53131A-07A

S E R V I C E N O T E

Supersedes:
53131A-07

53131A - 225 MHz Counter

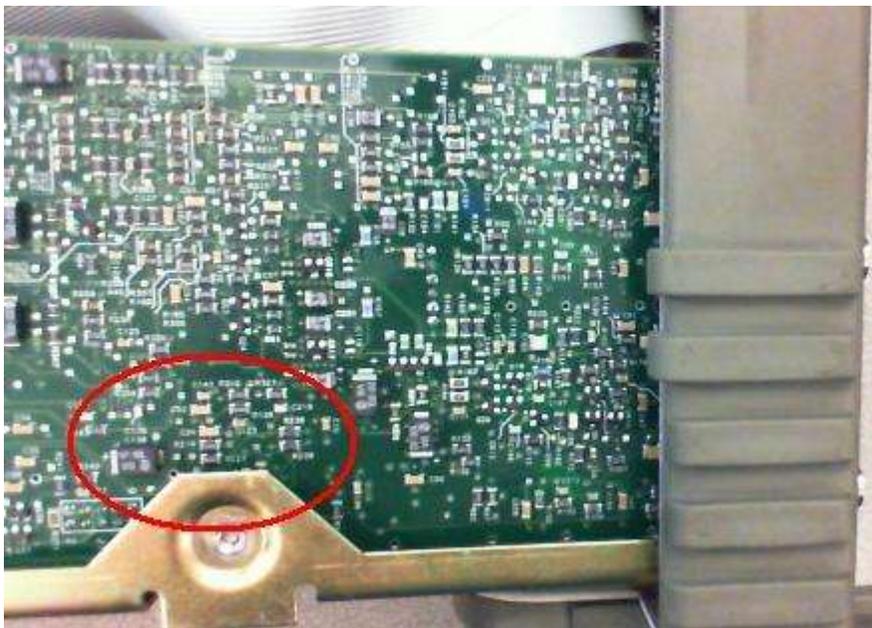
Measurements on counters with A1 motherboard (53131-68024 or 53132-68024) may have intermittent readings that are significantly outside the specified accuracy under the following conditions:

- Channel 1 is configured to use Auto Trigger Level,
- AND**
- Channel 2 either:
 - has been used to make a measurement since the last power cycle, or
 - has been used to make pulse width, time interval or rise/fall time measurements (including Channel 1 measurements with Common 1: ON), or
 - has an input signal with an amplitude >10 Vpp

Replace resistor 0699-1318 at reference designators R219 and R218 with 0699-1377 (2.37 KOhm).
